Service Bulletin

Bulletin No.: 22-NA-248

Subject: HVAC Heat Intermittently Inoperative, DTCs B2B05 and/or B2B06 Set

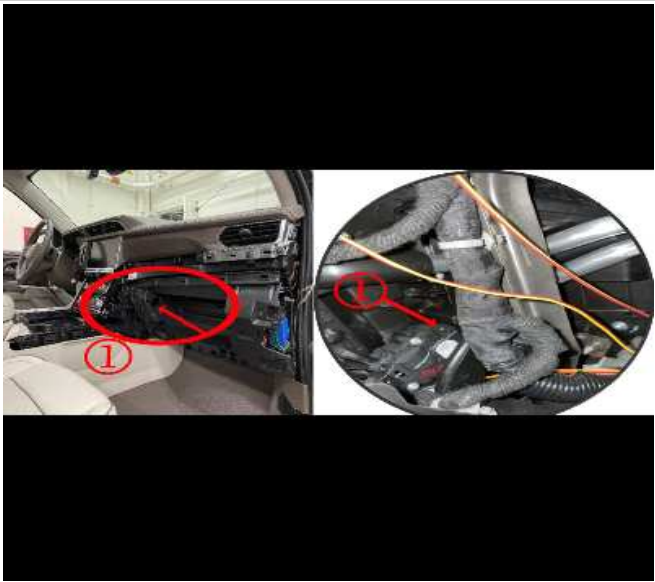
Correction	 6213239  6213261 Visually inspect the right side temperature valve actuator (1) and the left side temperature valve actuator (2) for a yellow dot, as shown in the pictures above, that indicates the parts were manually re-flashed. If the yellow dot is present, replace the temperature valve actuator.
-------------------	---

Refer to Temperature Valve Actuator Replacement in SI.
